Japanese position on the Proposal for a new draft regulation: Uniform provision concerning the approval of wheels for passenger cars and their trailers

Submitted by Japan

Annex 2

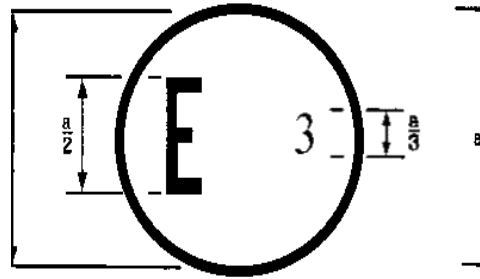
Annex 2. Amend to read

The marking of approval mark, approval number and Regulation No. may be at a distance from each other.

Some wheel design might not give enough space to arrange the approval mark in one place.

Figure 1 – Impact loading test machine

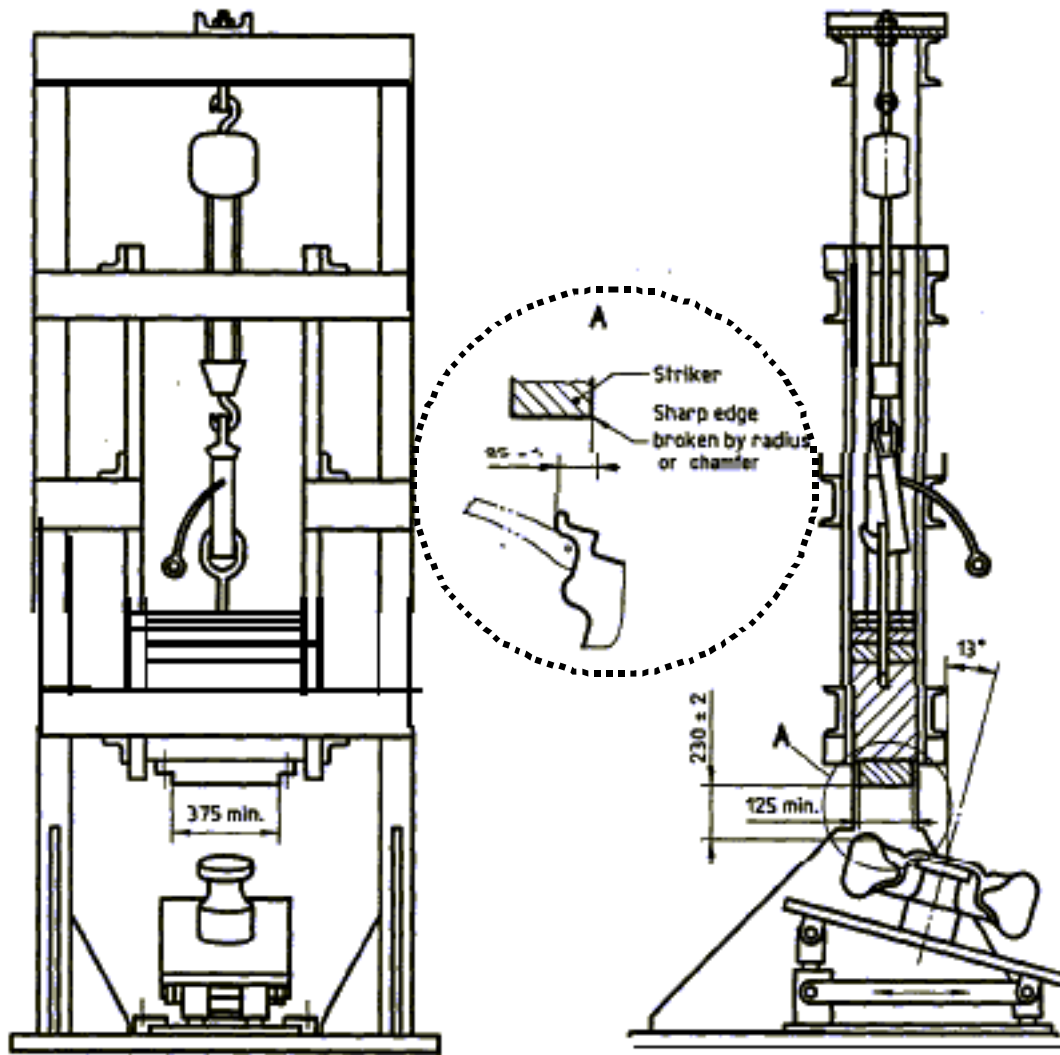
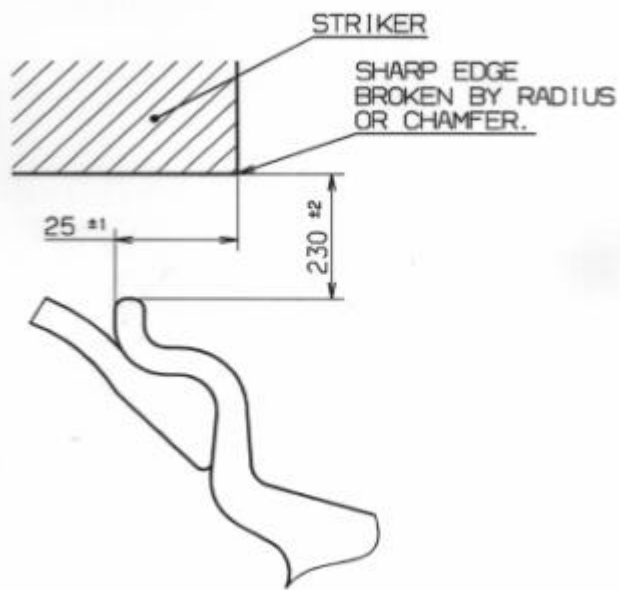
Detail A shown in Annex 8 Appendix 1 figure 1, correct as shown below:
